### 11 01 12 (RR04)

**Title: Recall Campaign 11V-522: Replace the Auxiliary Coolant Pump for Turbocharger (KIT- 01)**

**Affected cars:** Rolls-Royce Ghost models produced between 01/09/2009 and 01/10/2010

Figure 1

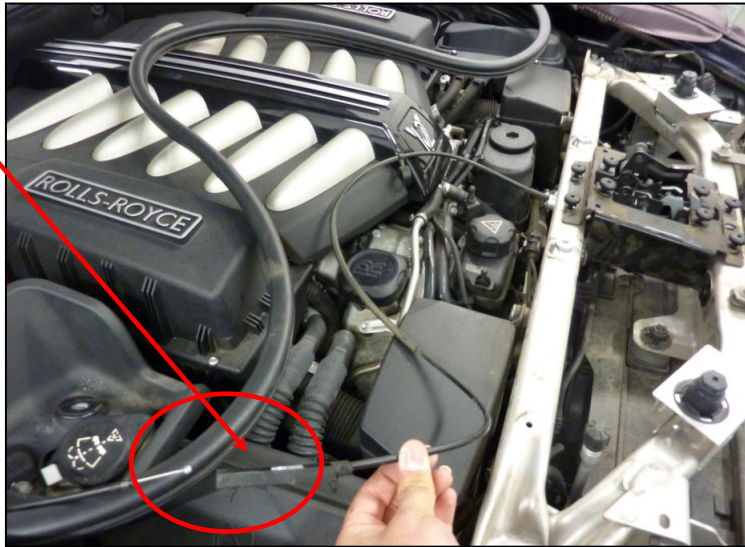
Document Number	Document title	Comments
51 76 ...	Removing and installing/replacing front cover for engine compartment	No comments
51 11 ...	Removing and installing/replacing upper radiator grille cover	No comments
51 11 ...	Removing and installing/replacing side left or right radiator grille frame	No comments
51 13 145	Removing and installing/replacing retraction mechanism of Spirit of Ecstasy	No comments
51 13 000	Removing and installing/replacing the centre radiator grille	<b>Note:</b> Do not remove front bumper trim (51 11 156 Removing and installing front bumper trim)
51 64 026	Removing and installing/replacing upper front connection (cross member)	<b>Note:</b> Disconnect bonnet catch/ lock bridge Bowden cable as shown in Figure 1 below

Figure 1, circled above, shows bonnet catch/ lock bridge Bowden cable disconnected
